Carrigaline UDF and Public Realm

Stage 1 - Road Safety Audit

Cork County Council

July 2023

Figure 2-2 - Service Access and Adjacent Features

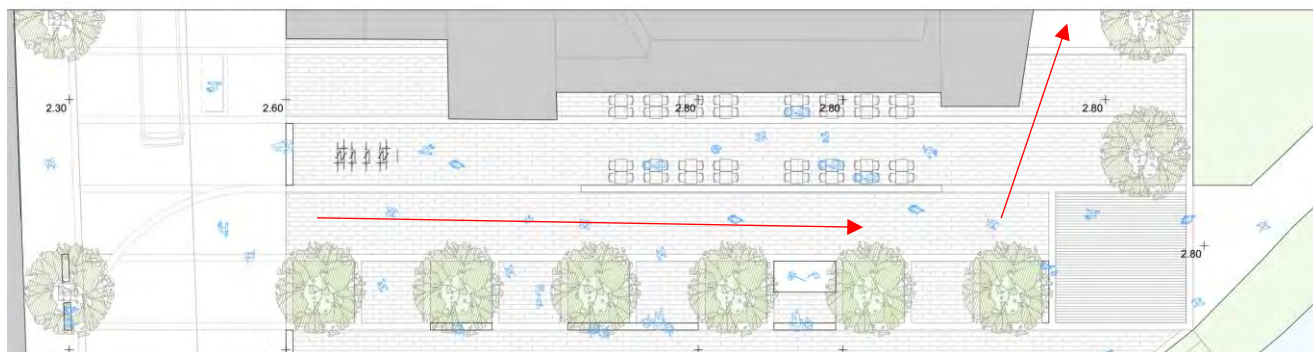
The proposed layout includes some features such as large trees and low walls/benches adjacent to the service/delivery vehicle access route which may cause an obstacle for the large service/delivery vehicles that will likely be using the route. The proposed layout also indicates that the service/delivery vehicles will be forced to turn and travel in very close proximity to the south-eastern corner of the cluster of commercial buildings with exits/entrances along this eastern side of the building block. These potential obstacles may lead to collisions causing material damage or injury.

The separation to entrances/exits and the selection and siting of trees and other physical features should be considerate of the likely traffic using the service/delivery route.

Figure 2-4 - Proposed Details of the Stepped Embankment

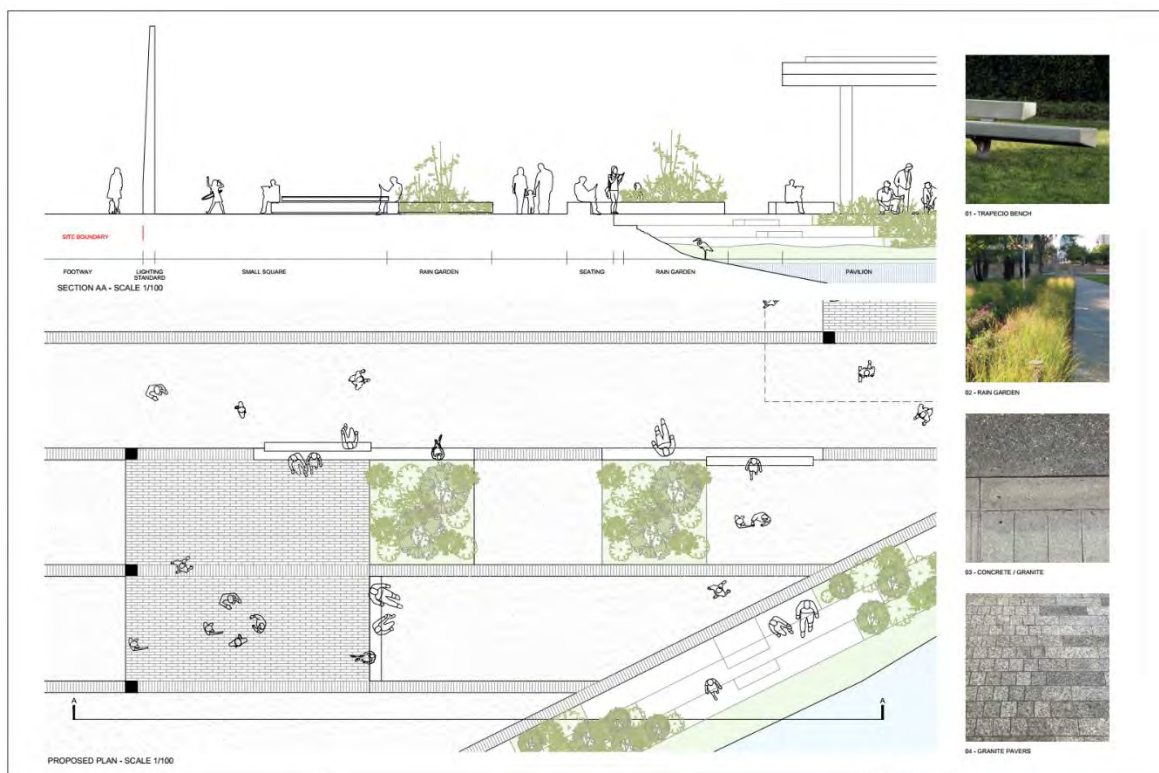
It is unclear from the drawings whether the stepped embankment is above the maximum tidal water level, if not the steps could become slippery from deposits of mud and algae resulting in slips trips and falls.

In addition, it is unclear from the drawing whether the existing railing along the south side of the existing footpath from beyond the proposed embankment area is to be removed or replaced. If no railing is provided this could lead to pedestrians or cyclist falling into the river. The Owenabue River is a significant width and depth, which would increase the severity of an incident such as this.

Ensure that adequate protection measures are in place to prevent falls into the river along the entire length of the scheme.
